Docket No. 52-048

SUBJECT: NuScale Power, LLC Submittal of Changes to Final Safety Analysis Report, Section 8.4

Enclosure: "Changes to NuScale Final Safety Analysis Report Section 8.4"

Figure 8.4-1: Station Blackout Reactor Pressure Vessel Water Level Above Top of Active Fuel

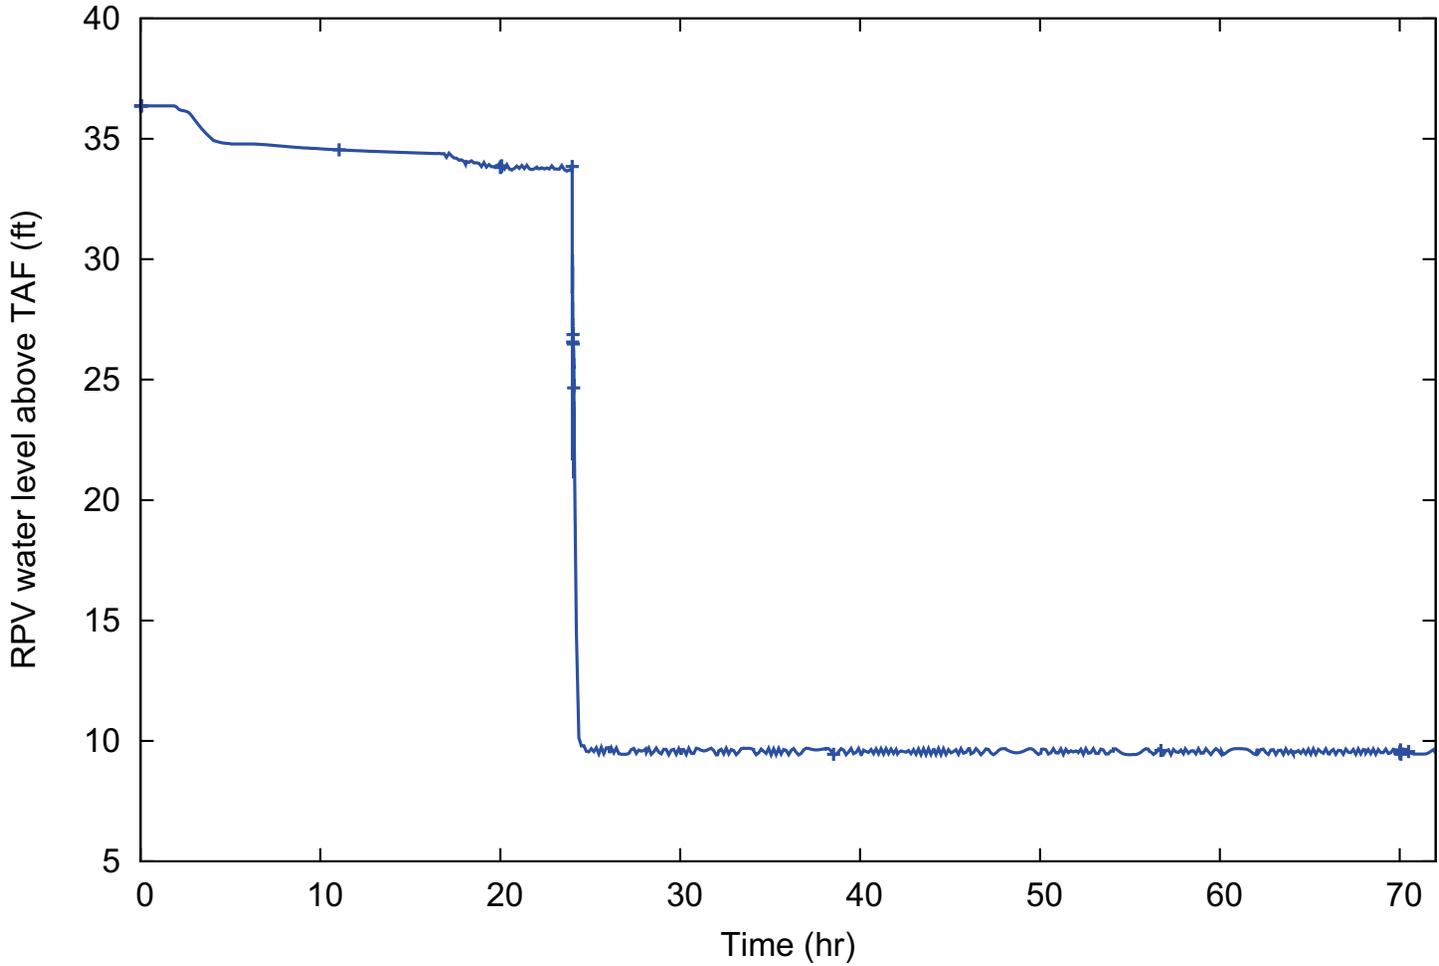
Within one minute, the DHRS begins to transfer heat from the reactor to the reactor pool and continues to operate for the event duration. ~~Under DHRS cooling, the reactor coolant system pressure and temperature continually decrease.~~ After 24 hours, the MPS actuates the emergency core cooling system (ECCS), and the ECCS vent and recirculation valves automatically open. At this point, ~~T~~he pressure and water level in the reactor pressure vessel (RPV) ~~rapidly~~ decrease, and containment vessel (CNV) pressure rapidly increases until equilibrium is reached. The DHRS cooling then declines in favor of cooling through the CNV wall via reactor coolant that circulates through the CNV. Stable cooling continues to the end of the transient, with a continued slow decrease in the temperature and pressure in the RPV and CNV. The water level in the RPV remains stable at more than ~~109~~ feet above the top of the active fuel.

Figure 8.4-3: Station Blackout Containment Vessel Pressure

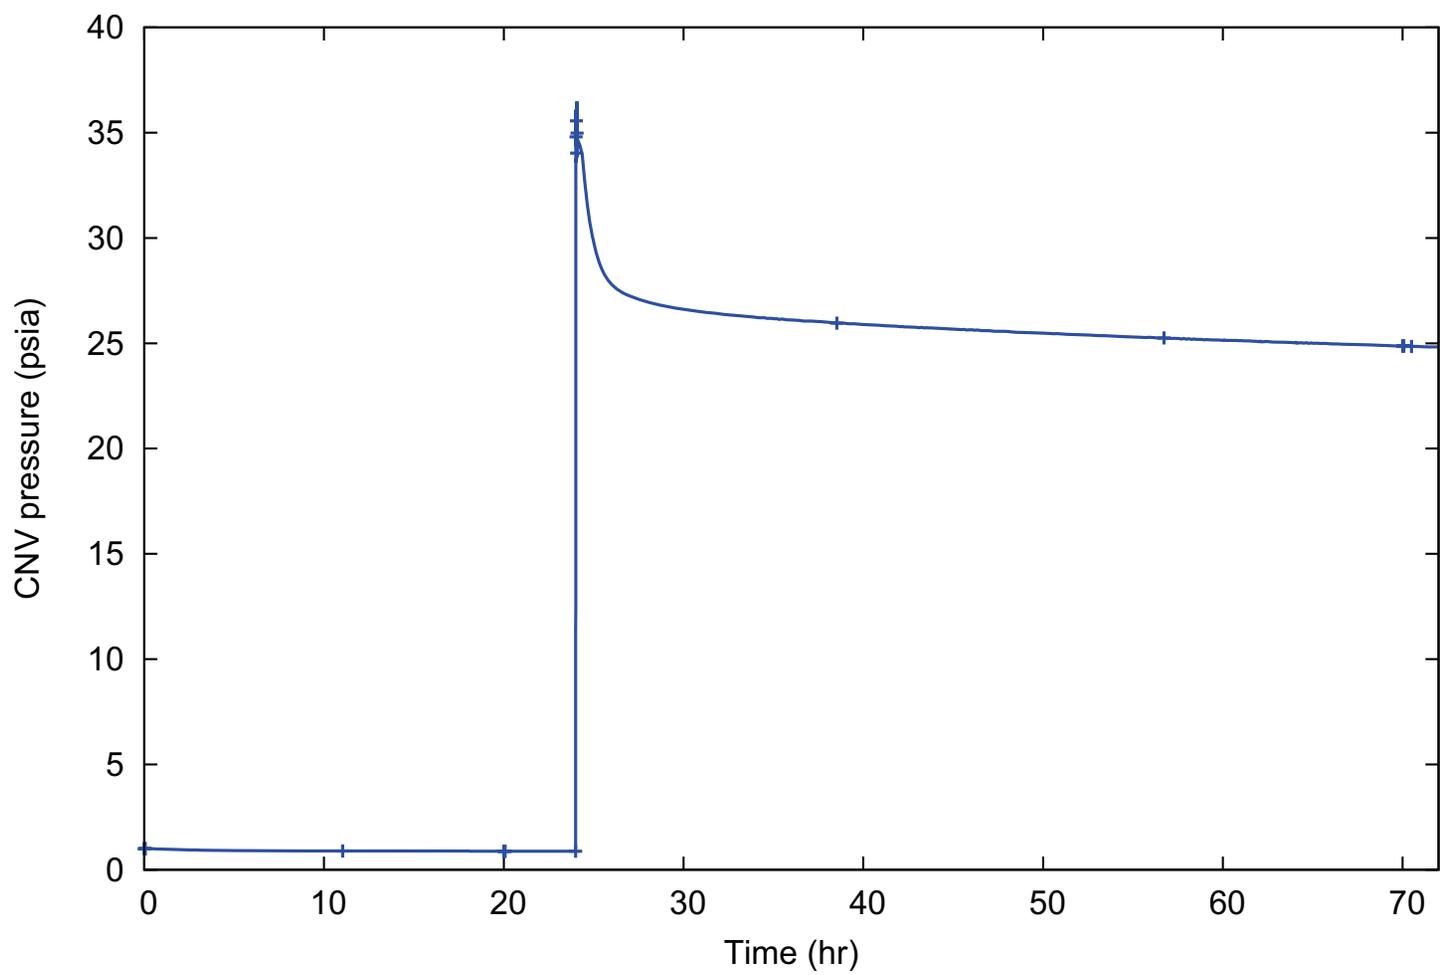
The analysis results show that a safe and stable shutdown is achieved, and that the reactor is cooled and containment integrity is maintained for the 72-hour duration with no operator actions. The core remains subcritical for the duration of the event. The reactor coolant inventory ensures that the core remains covered without the need for makeup systems. The RPV water level is well above the top of active fuel as shown in Figure 8.4-1. After the reactor trips ~~and the RSV operates~~, the RPV pressure decreases rapidly and stabilizes at low pressures as shown in Figure 8.4-2. In addition, containment pressure and temperature are well below the design limits of 1000 psia and 550 degrees F as shown in Figure 8.4-3 and Figure 8.4-4.
